Note Proposed Amendments: (added text to the code is: underlined, deleted text to the code is: ~~struck through~~)

ITEM	SECTION	SUMMARY	PROPONENT	ACTION
IRC-2024-01	PREFACE Part IV Chapter 11	Part IV, Energy Conservation (Chapter 11) is deleted from the INTERNATIONAL RESIDENTIAL CODE FOR ONE- AND TWO-FAMILY DWELLINGS. Substitute all references to Chapter 11 ENERGY EFFICIENCY with references to the <i>Georgia State Minimum Standard Energy Code (International Energy Conservation Code with Georgia State Supplements and Amendments)</i> .  <i>James Martin made a motion to carry forward with Chuck Wooley as second. Motion passed unanimously.</i>	2020 amendments	CF
IRC-2024-02	PREFACE Part VII	Part VII, Plumbing (Chapters 25 through 33), is deleted from the INTERNATIONAL RESIDENTIAL CODE FOR ONE- AND TWO-FAMILY DWELLINGS. Substitute for plumbing requirements the <i>Georgia State Minimum Standard Plumbing Code (International Plumbing Code with Georgia State Amendments)</i> .  <i>James Martin made a motion to carry forward with James Brooker as second. Motion passed unanimously.</i>	2020 amendments	CF

\*Note: These amendments are “proposed only” and have not been adopted by the Department

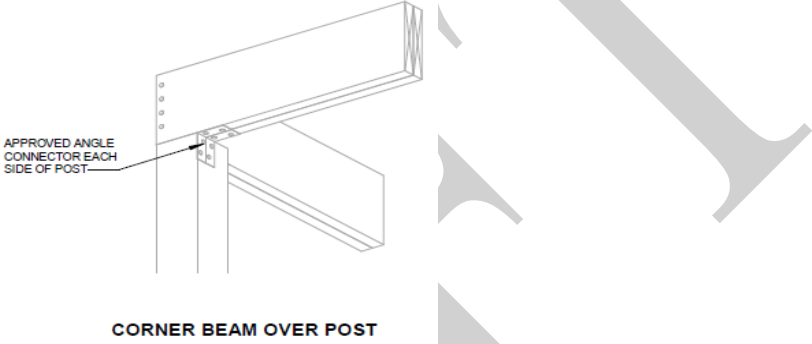
IRC-2024-25	R311.2.1	<p>Revise Section <del>R311.2.1</del> ‘New Construction’ to read as follows:  <b>R311.2.1 New construction.</b> For new construction, carbon monoxide alarms shall be provided in dwelling units <del>where either or both of the following conditions exist.</del>  <del>1. The dwelling unit contains a fuel fired appliance.</del>  <del>2. The dwelling unit has an attached garage with an opening that communicates with the dwelling unit.</del></p> <p>Chuck Wooley made a motion to approve as revised with Alan Cannon as second. Motion passed unanimously.</p>	2020 amendments	R

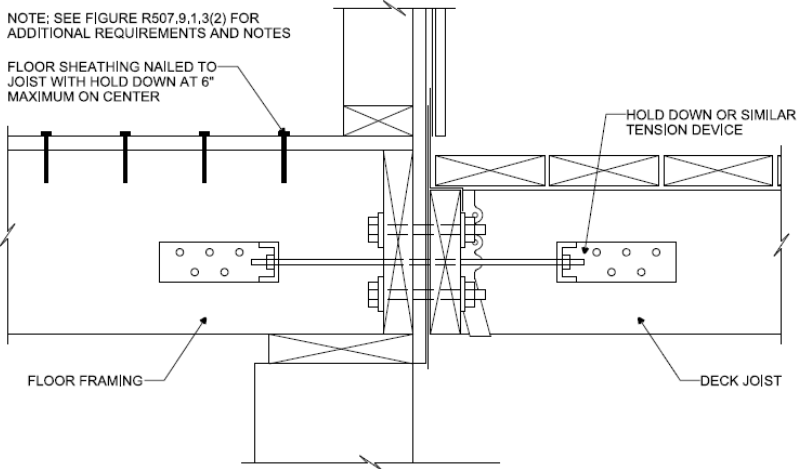
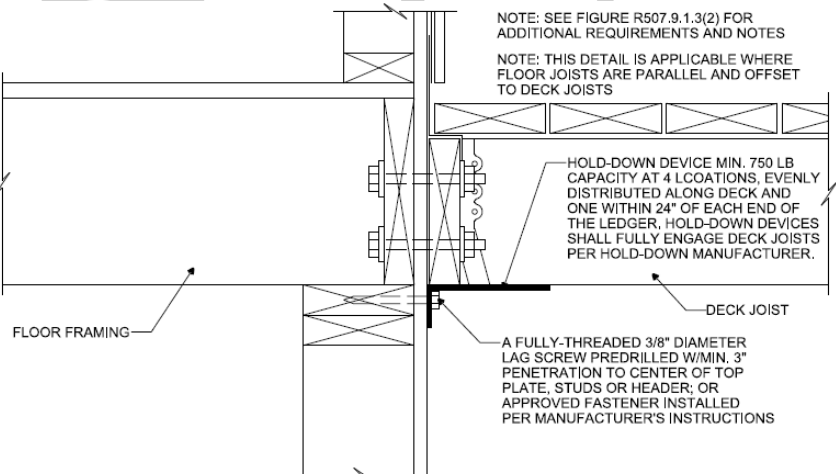
ITEM	SECTION	SUMMARY	PROPONENT	ACTION
IRC-2024-29	R507.5.2(1)	<p>Revise Figure R507.5.2(1) ‘DECK BEAM TO DECK POST’ to include a new illustration for “Corner Beam Over Post” as follows:</p>  <p>Alan Cannon made a motion to carry forward with Derrick Daniel as second. Motion passed unanimously.</p>	2020 amendments	CF
IRC-2024-30	R507.9.1.3	<p>Revise section R507.9.1.3 ‘Ledger to band joist details’ to read as follows.</p> <p><b>R507.9.1.3 Ledger to band joist details.</b> Where ledgers are fastened in accordance with Table R507.9.1.3(1), fasteners shall comply with Section R507.2.3 <u>or other approved fasteners</u> and shall be installed in accordance with Table R507.9.1.3(2) and Figures R507.9.1.3(1) and R507.9.1.3(2). Holes for 1/2-inch (12.7 mm) lag screws shall be predrilled with two drill bits so that a hole 1/2 inch (12.7mm) in diameter is drilled through the ledger and sheathing, if present, and a hole 5/16 inch (7.9 mm) to 3/8 inch (9.5mm) in diameter is drilled through the band joist.</p> <p>James Martin made a motion to approve as revised with Chris Keeling as second. Motion passed unanimously.</p>	2020 amendments	R
